PROJECT NAME
Alpine Street Garage

PROJECT ADDRESS
11-15 ALPINE STREET
SOMERVILLE, MA

REVISION TO ZBA 2016-75
September 16, 2021

List of Changes; Refer to Accompanying Narrative.

A-100

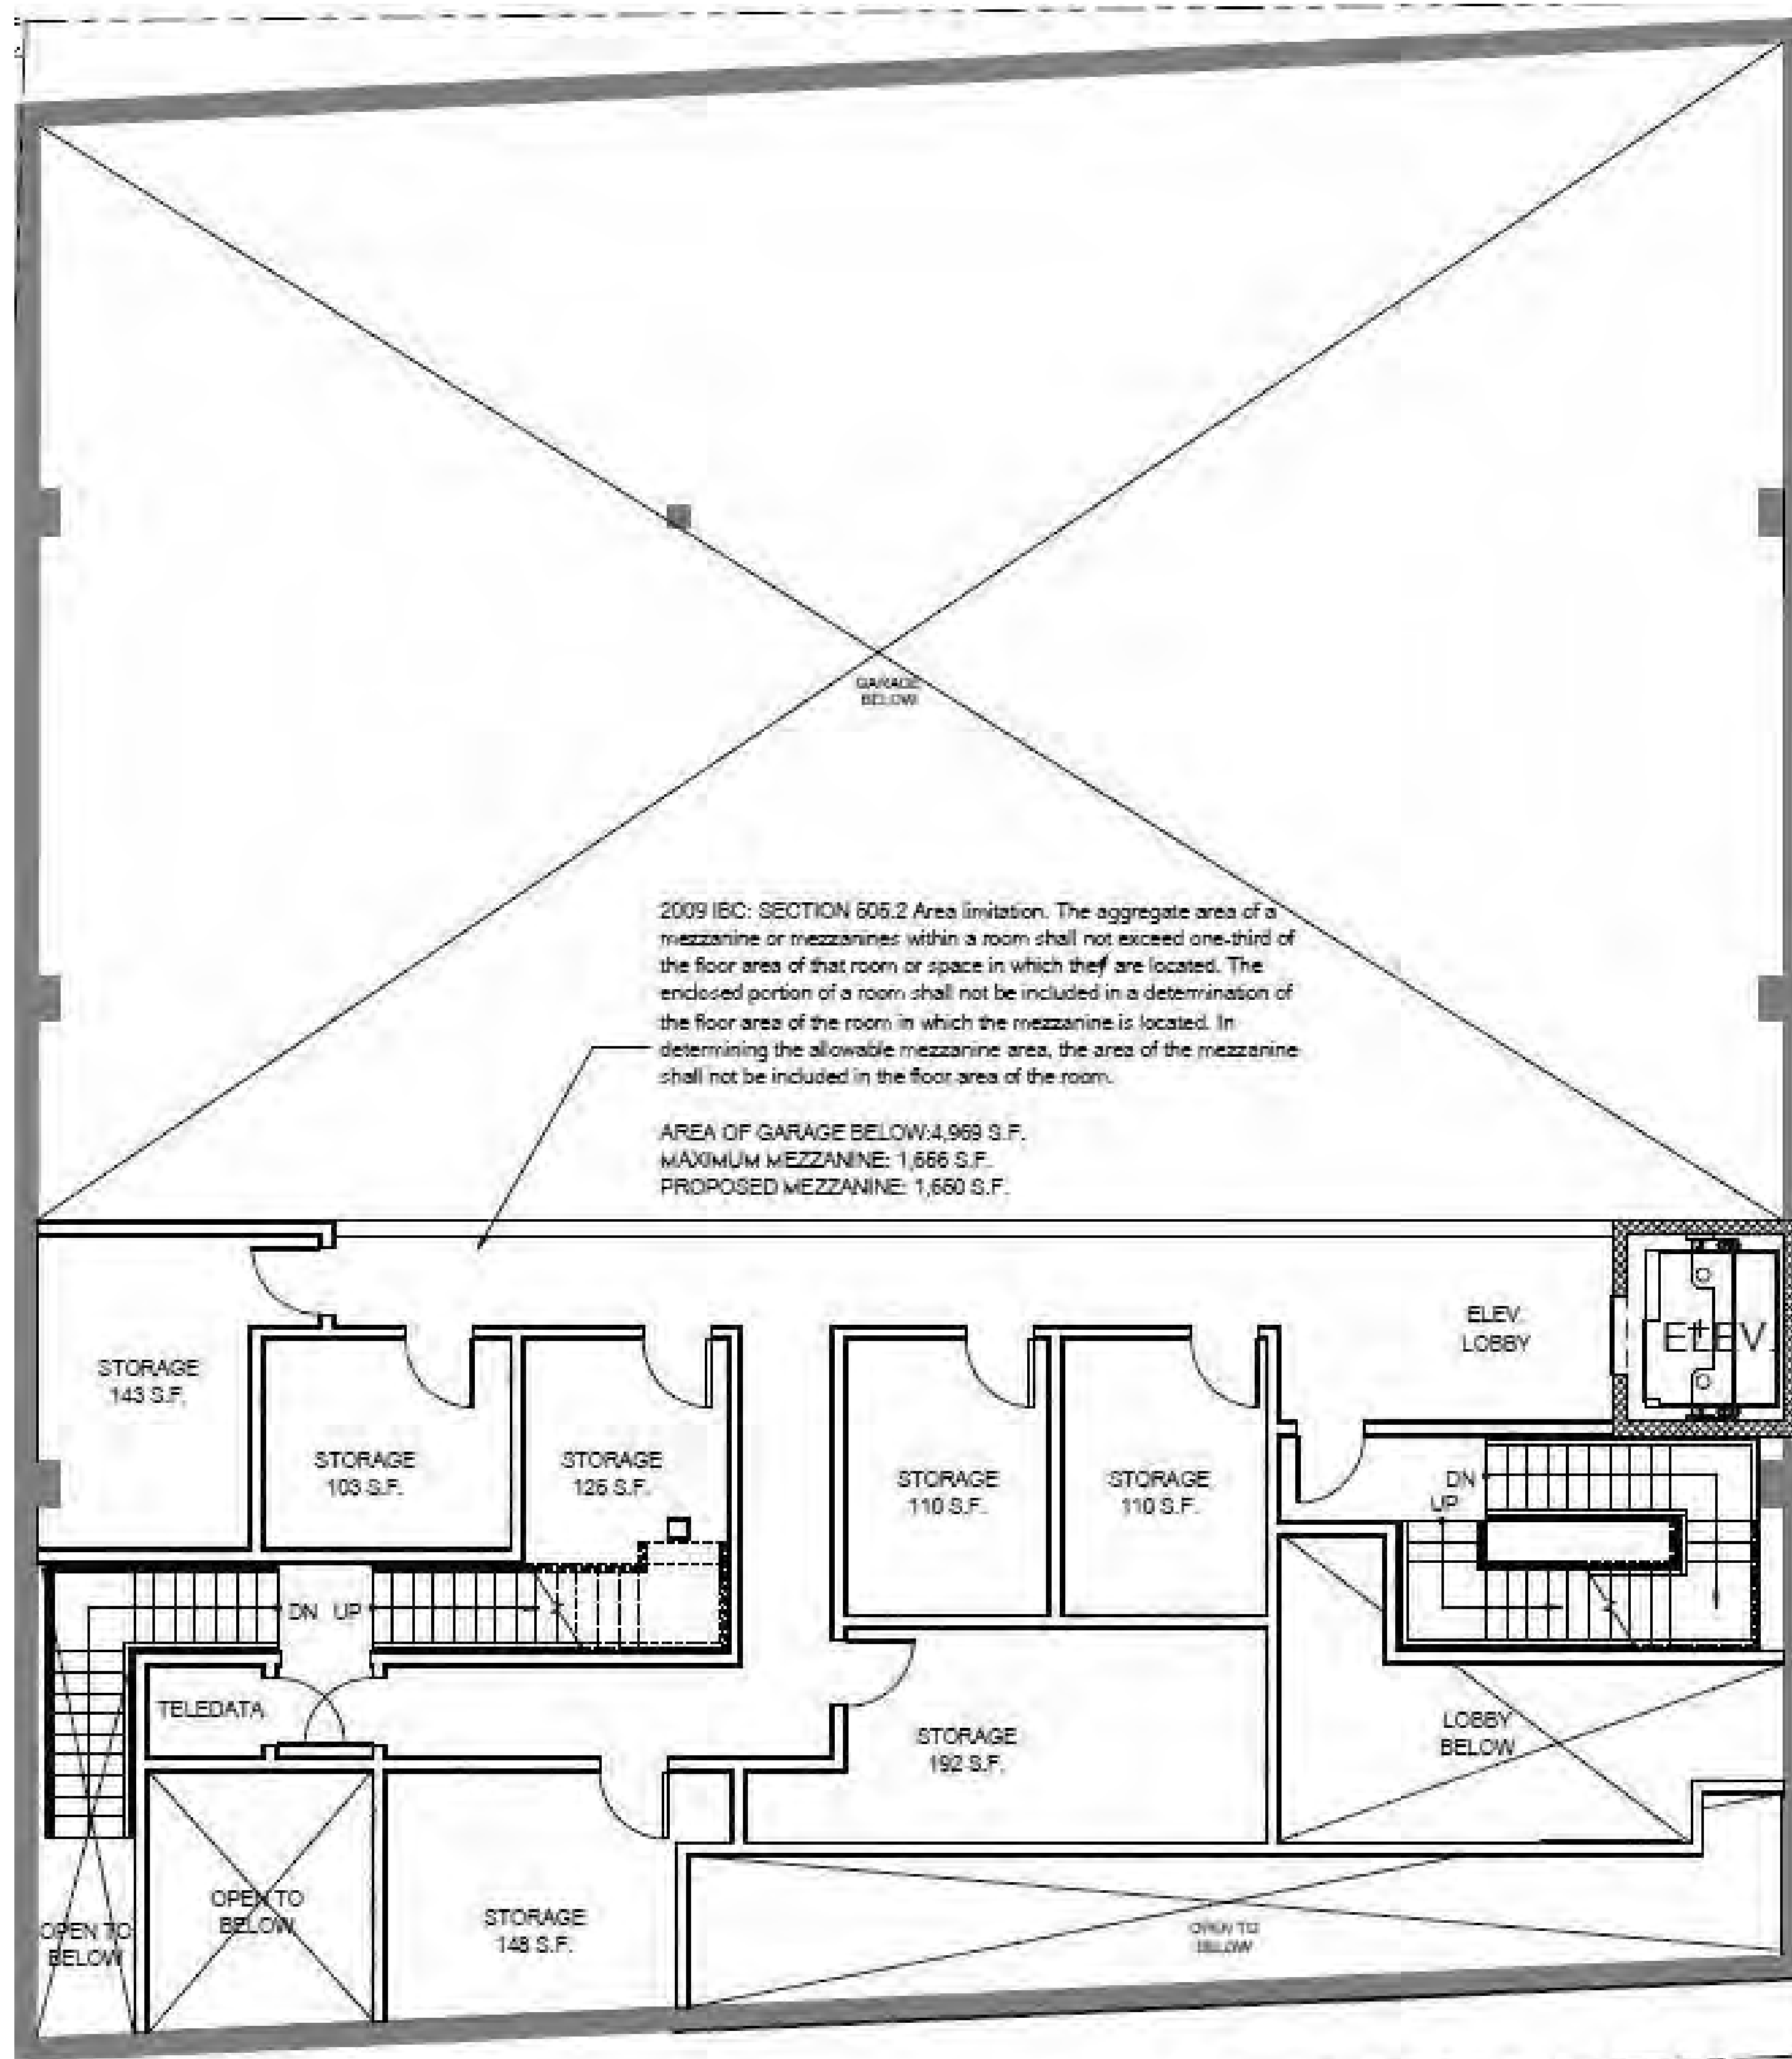
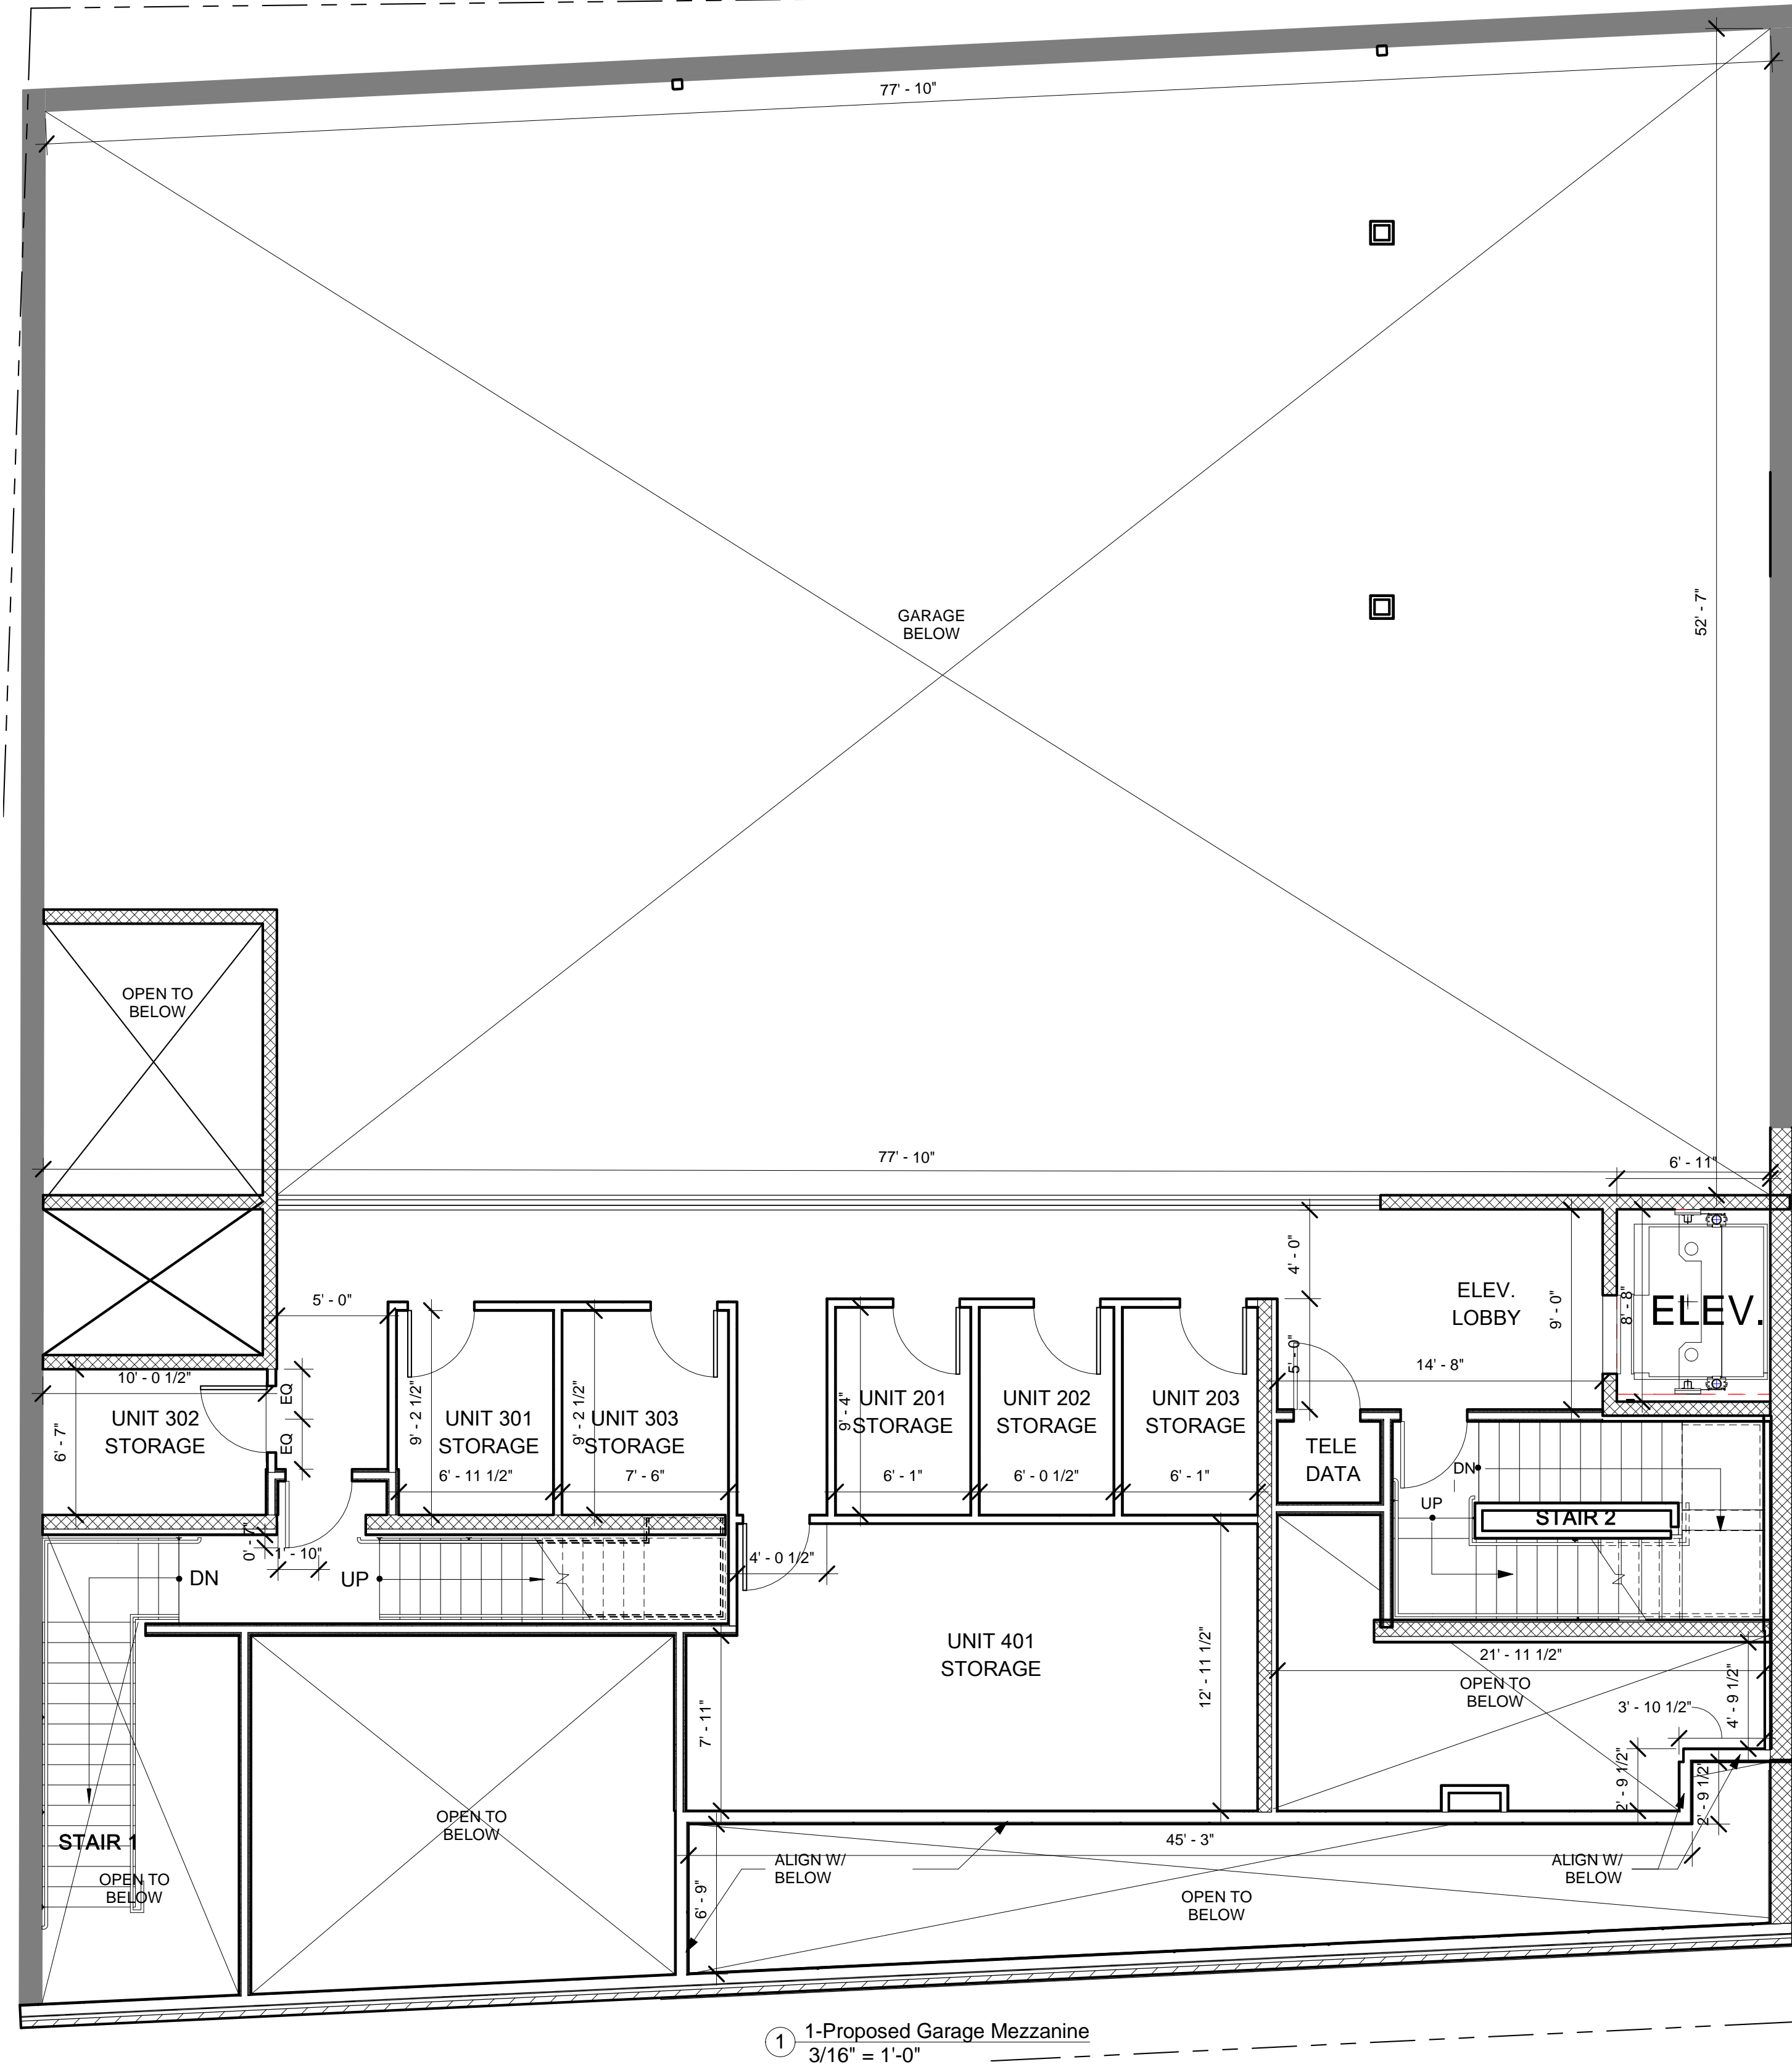
5. CMU Block is used at the
east side garage wall in lieu of
opaque glazing.

12. The ground floor front 2' high granite
planters will be replaced with cast
concrete planters at the front of the
building.
